Product Change Notice (PCN)

PCN Number: PCN-0451316R-01

Product(s) Affected: PD-30

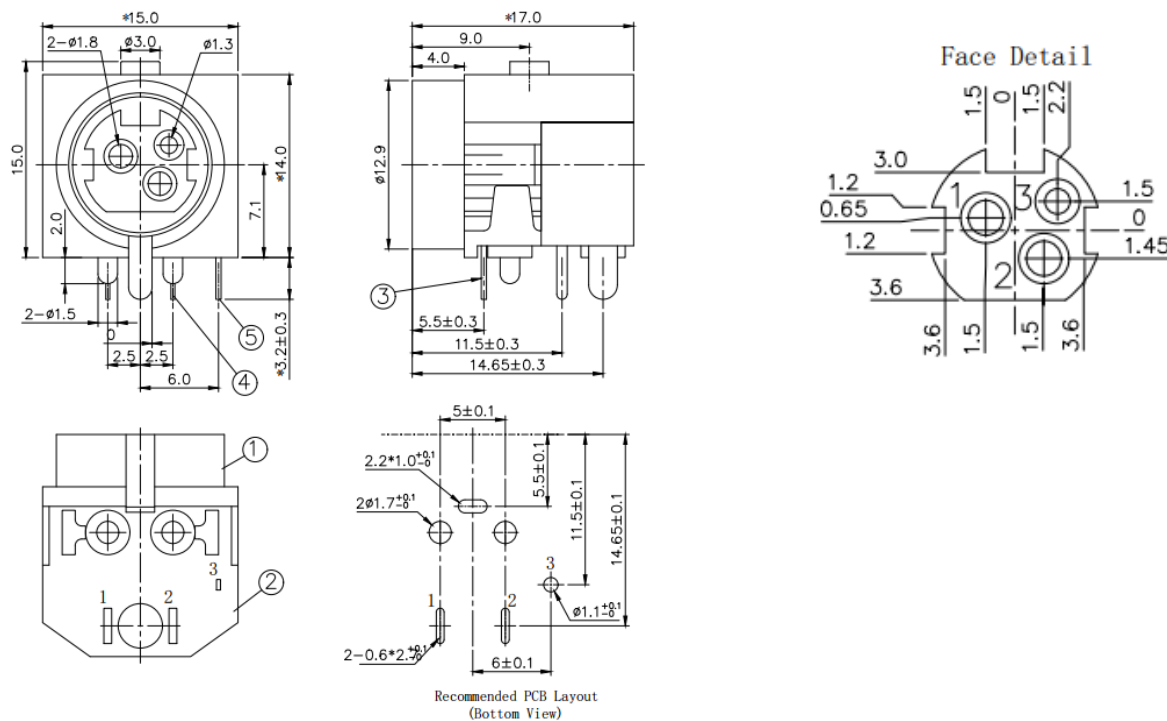
Description of Change: Small dimensional changes, shown in the drawing below

OLD

NEW
